Access Compliance Report Public Rights-of-Way (Curb Ramps)

Main Street: CRESTVIEW Cross Street: CASTLETREE Location: N

ADA ID: RPRK211018152457 Ramp Type: Type 1 - Perpendicular Diagonal Initial Pass/Fail: Fail Overall Compliance: No Severity Score: 30

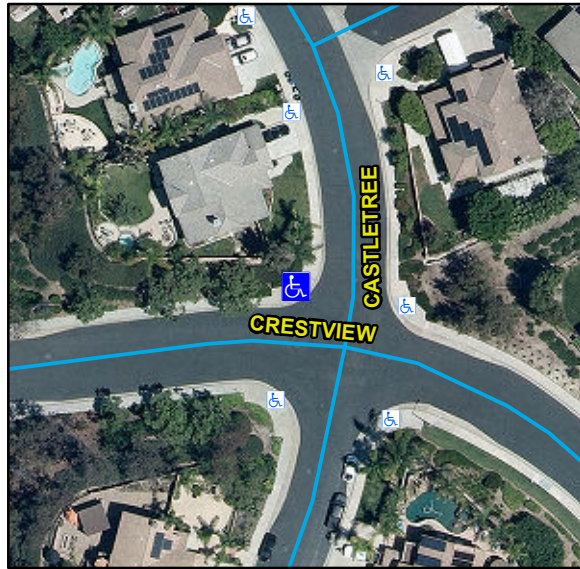
R204.3, R304.2.2, R304.5.3, R302.7.2, STD 1115

Remove & Replace Curb Ramp With Two New Directional Ramps or Equivalent. Grind Gutter Lip.
